**BROWNS FERRY NUCLEAR PLANT (BFN) - UNITS 1, 2, AND 3 -
TECHNICAL SPECIFICATIONS (TS) CHANGES TS-431 AND TS-418 -
EXTENDED POWER UPRATE (EPU) - RESPONSE TO ROUND 6 REQUESTS
FOR ADDITIONAL INFORMATION (TAC NOS. MC3812, MC3743, AND
MC3744)**

**TECHNICAL SPECIFICATIONS (TS) CHANGES TS-431 AND TS-418 -
EXTENDED POWER UPRATE (EPU) - RESPONSE TO ROUND 6 REQUEST FOR
ADDITIONAL INFORMATION (TAC NOS. MC3812, MC3743, AND MC3744)**

RESPONSES TO REQUESTS FOR ADDITIONAL INFORMATION

FIGURE ACVB.56/54-5 NPSH REQUIREMENTS FOR SBO (95°F SPRAY)

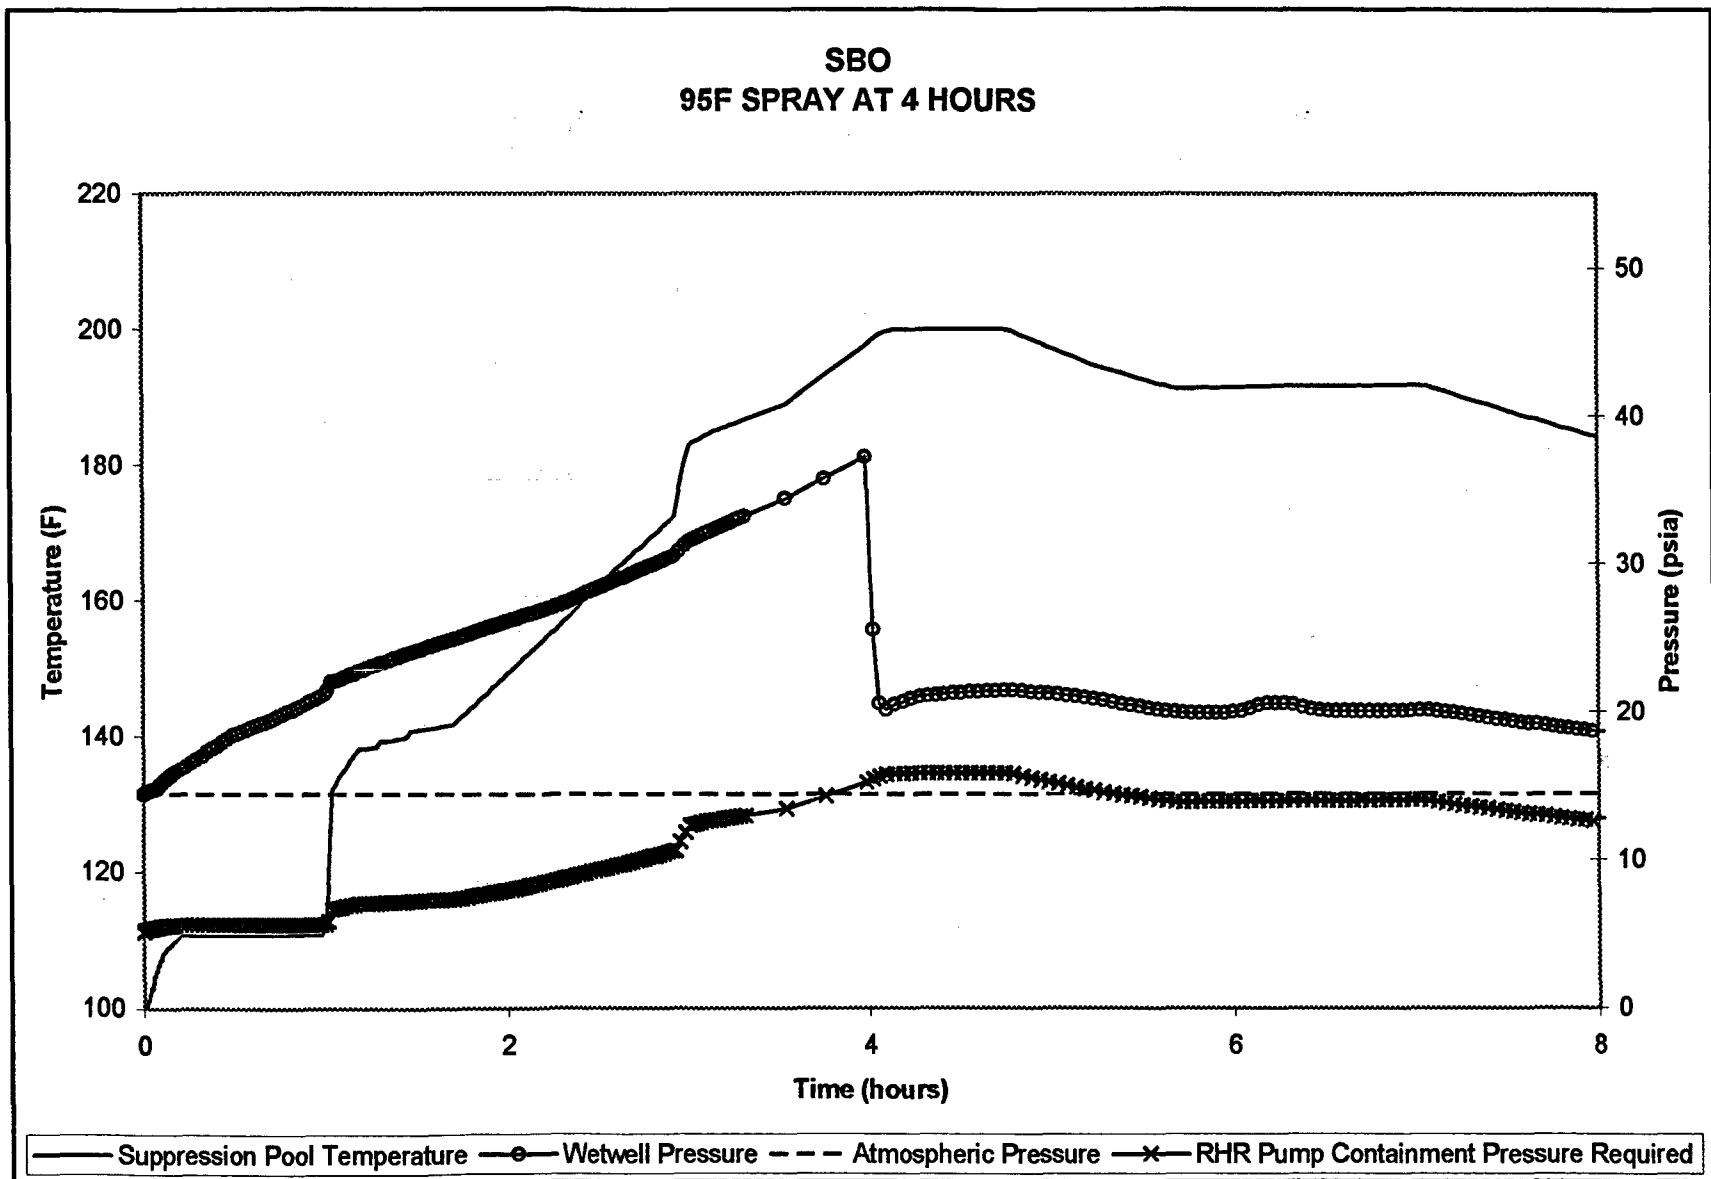
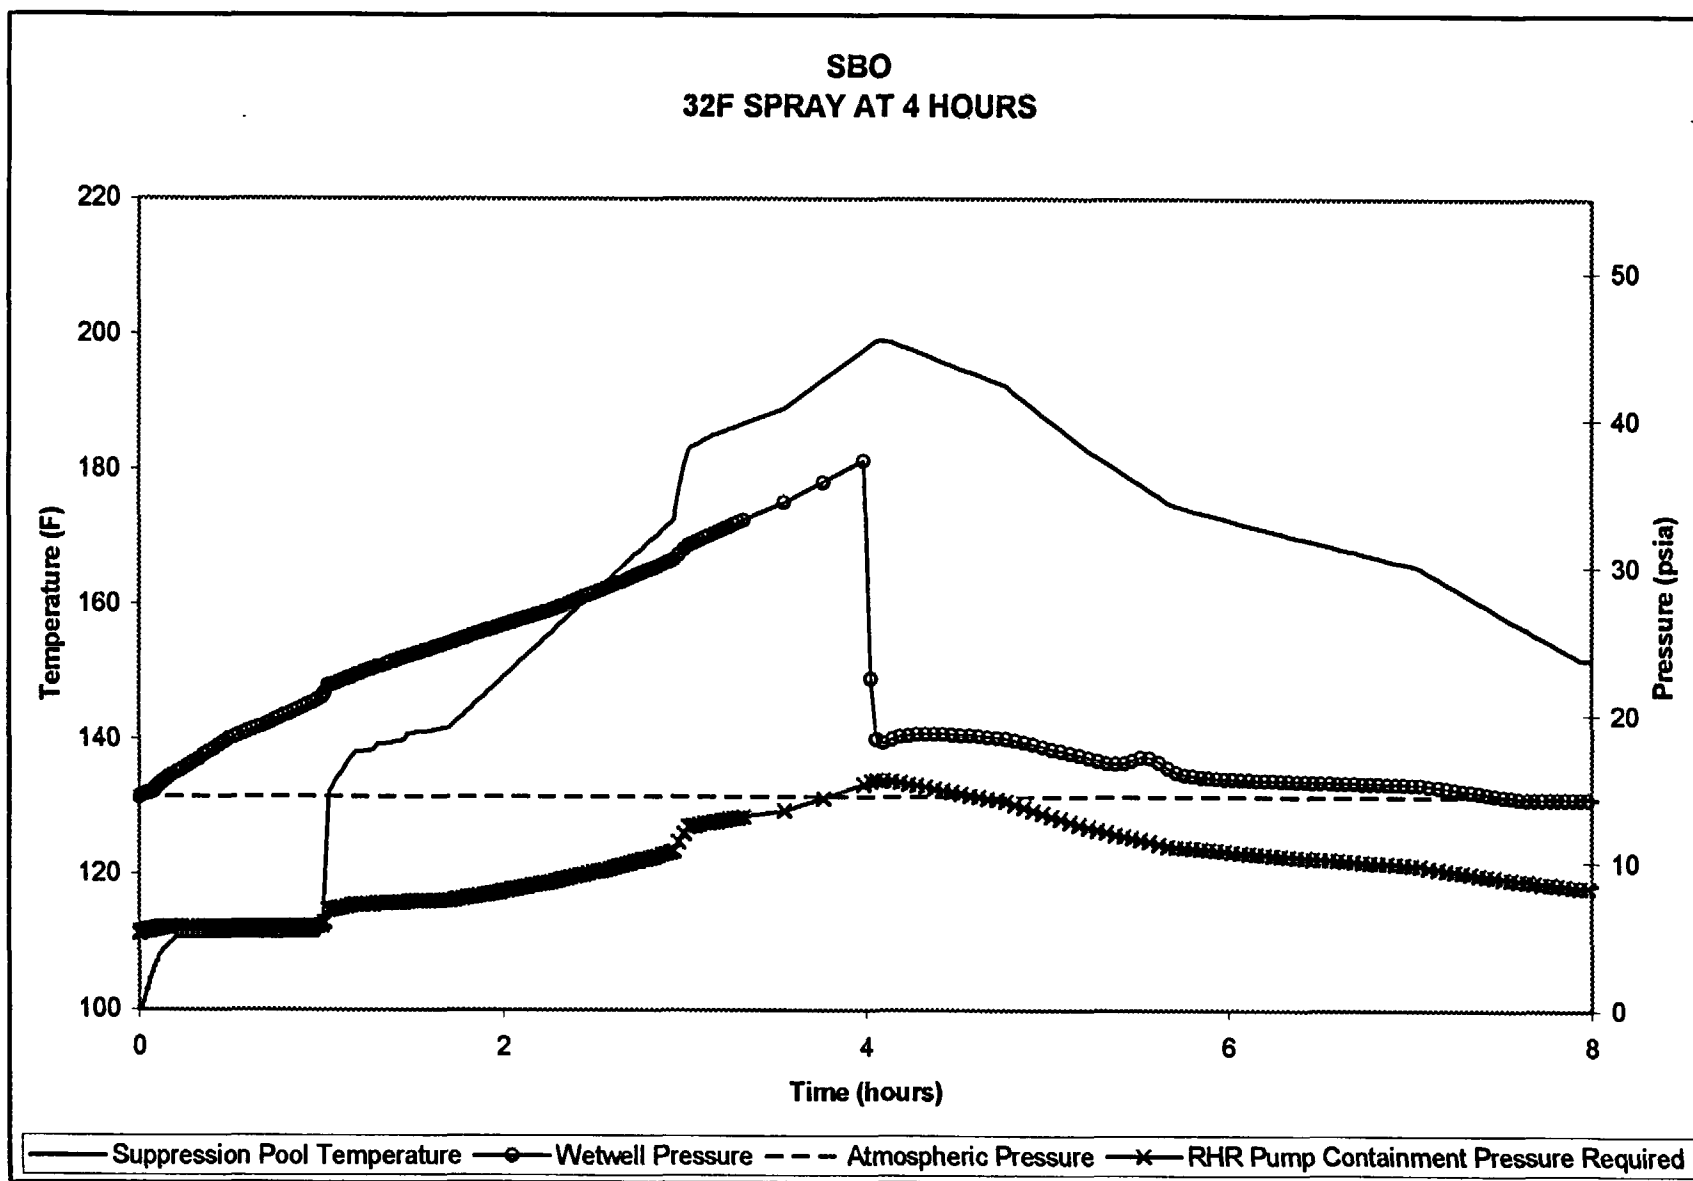
The response to RAI ACVB 18 provided curves of pressures and temperatures for the events crediting containment accident pressure for available NPSH. The curves for ATWS and Appendix R Fire should be extended to provide the total time that containment accident pressure is needed for available NPSH.

To address the discussions provided in TVA responses to ACVB.40/38 and 41/39, NPSH analyses have been re-performed for the LOCA long term, ATWS, Appendix R, and SBO events. Enclosures 3 and 4 are the supporting calculations. Figures ACVB.56/54-1 through 6 show the COP required and COP available for each case as a function of time. These graphs are extended to the time that containment overpressure is no longer needed to provide adequate NPSH.
